# SERVICE SLANTS

ISSUED BY WURLITZER SERVICE DEPT. NORTH TONAWANDA, N. Y.

## C A U T I O N

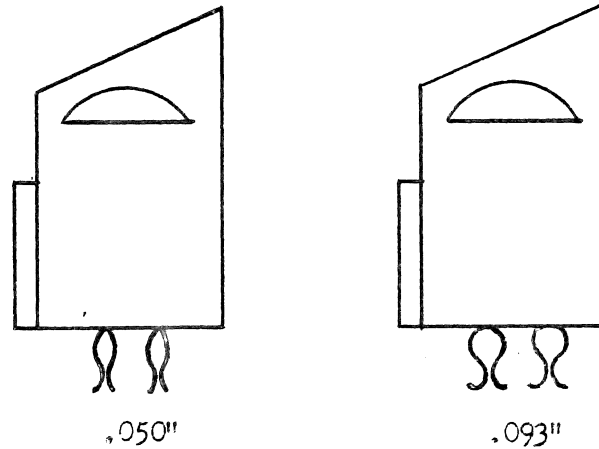
Please note the change in the contacts of the Zenith cartridges. The dimension between the contacts on cartridges we have had in past has been .050" and on the present cartridges this has been changed to .093".

If you should take a cartridge from your stock for the Model 1250 show jobs (having the .093" gap in the contacts) there is danger of it shorting out, it will be necessary to bend the contacts in slightly to overcome. This has been corrected in the cartridges that are included with this Wurlitzer Day demonstrator.

The contacts in the tone arm itself will be altered on all future production of the Model 1250 phonograph.

Therefore this applies to putting new cartridges in Model 1250 phonographs bearing low serial numbers.
